**Transmission Symptom - Oil Leakages on Transfer Box (SY 163/23)**

Model Line: **Macan (95B)**

Concerns: **Transfer box**

*Oil leakage on the transfer box*

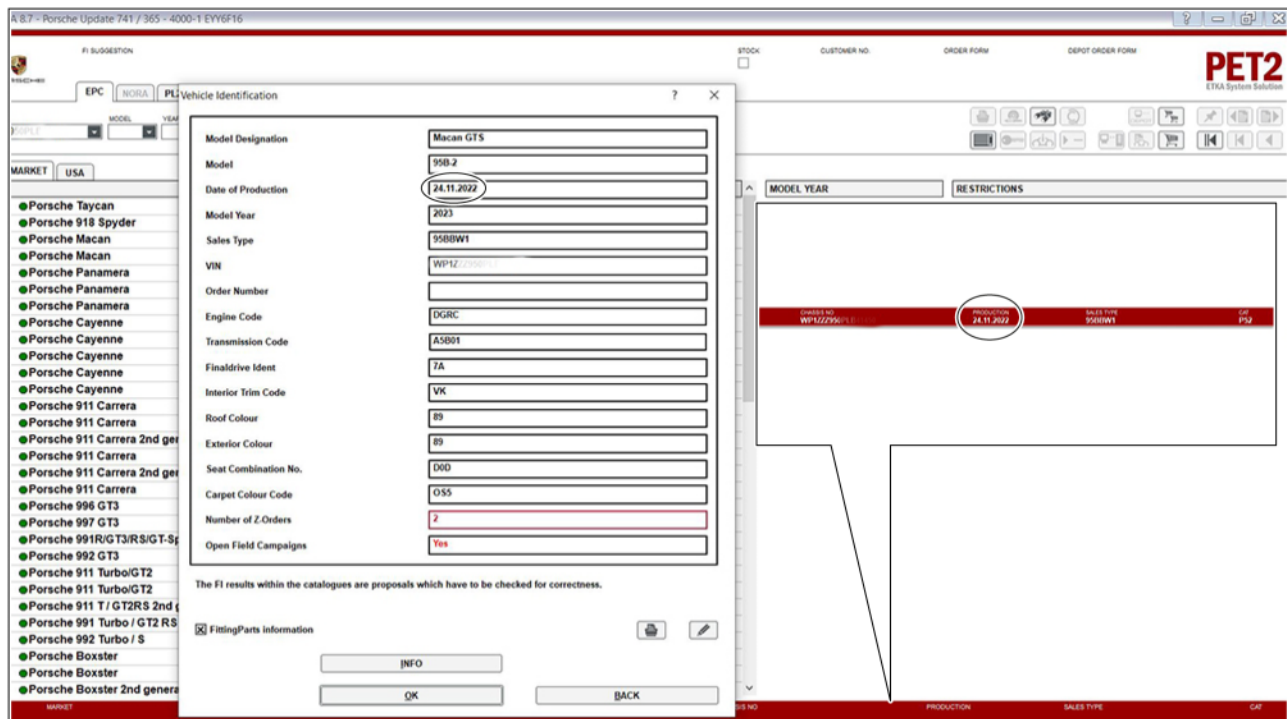
Symptom: Oil leakage is found on the vehicle in the area of the transfer box and at the transition to the double clutch transmission.

Cause: A temporary manufacturing error might have caused mechanical damage to the transmission input shaft in the area of the running track of the radial shaft seal ⇒ *Oil leakage on the transfer box*. This damage can lead to a leak on the radial shaft sealing ring of the transmission input shaft and thus to oil leakage on the transfer box.

Remedial Action: If an oil leakage is detected in the area of the transmission input shaft of the transfer box, check the production date of the vehicle and replace the transfer box depending on the test result. Replacing the radial shaft sealing ring is not sufficient for a damaged transmission input shaft.
